Maxtor Corporation
500 McCarthy Boulevard
Milpitas, CA 95035 USA

To: T10 SAS Protocol Working Group
Contact: Mark Evans
Phone: 408-894-5310
Email: mark_evans@maxtor.com
Date: 07 June 2004

Subject: SAS-1.1, ST_T (transport layer for SSP target ports) state machines

Figure 116 — ST_T (transport layer for SSP target ports) state machines

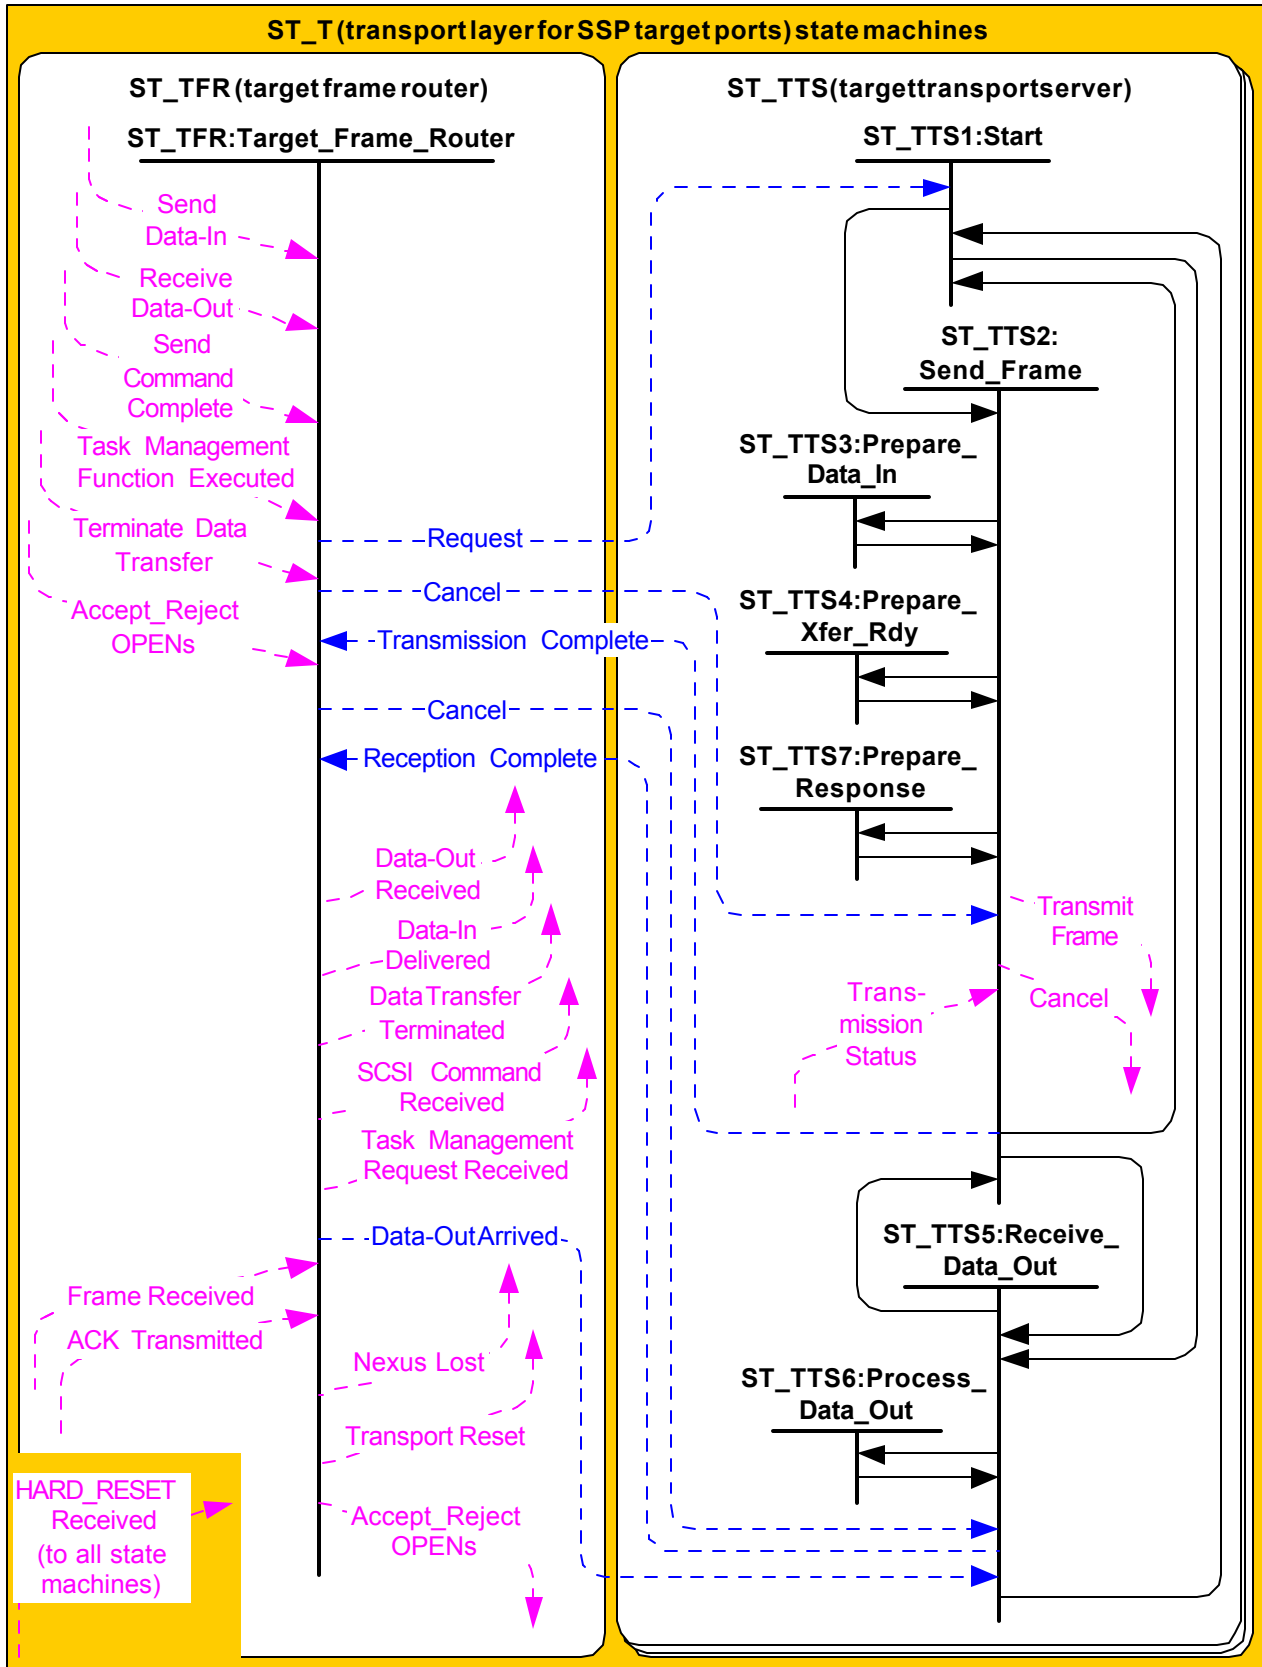
This proposal evolved from adding transport layer retries and the new protocol service, Terminate Data Transfer, to the SSP transport layer state machines. While including these elements, changes were made to simplify and clarify the description of these state machines. These changes include having all communication with the target's SCSI application layer be processed by the target frame router state machine, having a virtual target transport server state machine for each tag, and having the target transport server state machines be persistent between power cycles.

Having all communication with the SCSI application layer be processed by the target frame router state machine provides the ability for that state machine to maintain context for all tasks in process so that it can abort tasks as necessary. Having target transport servers for each tag provides the ability for one state machine to maintain context to process all elements of a task (e.g., XFER_RDY transmission, data transfer, and response). Having the target transport server state machines be persistent between power cycles simplified their description.

[Revision 1 of this proposal includes corrections to some Request \(Send Transport Response\) messages, clarification of overlapped tag responses, and other minor editorial corrections.](#)
